FORD ATX HARSH 2-3 UPSHIFT

Figure 1

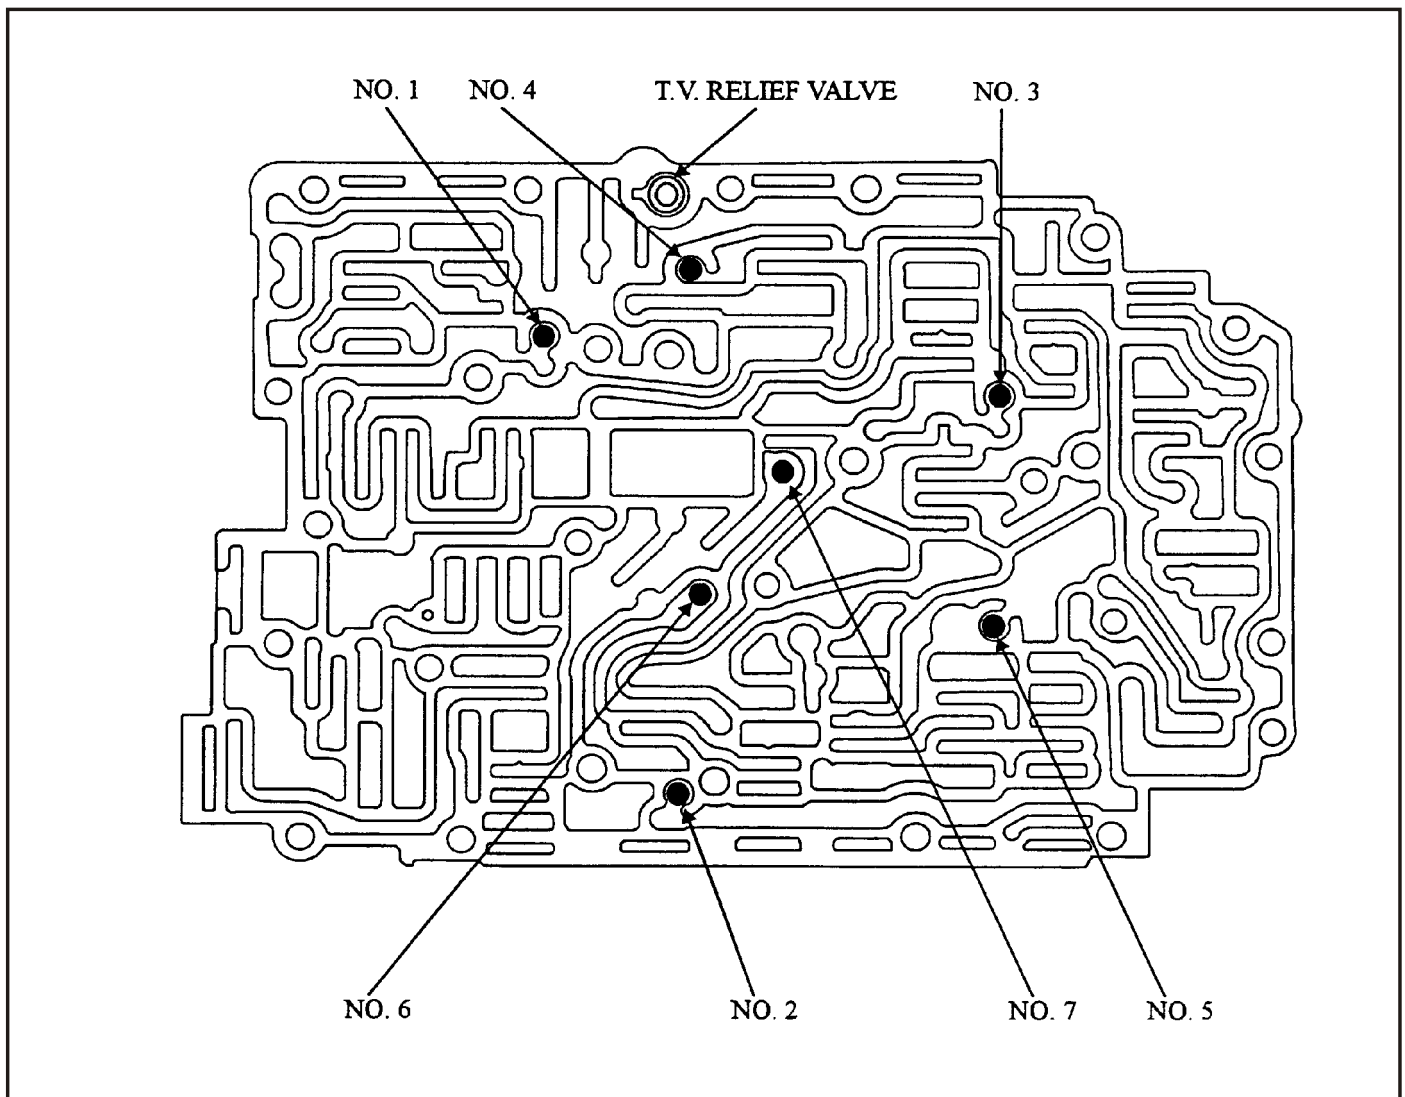
The number of main control check balls and their locations for the ATX transaxle as published in the 1989 Tempo/Topaz-Escort Car Shop Manual, Section 17-25-82 is incorrect. The correct number of main control check balls for the 1.9L ATX transaxle is seven (7) not six (6)(See Figure 1). Failure to install the seventh check ball will cause a harsh 2-3 upshift.

ACTION: When servicing the ATX transaxle main control make sure that all seven (7) check balls are installed. Refer to Figure 1 for the correct location of the main control check balls.
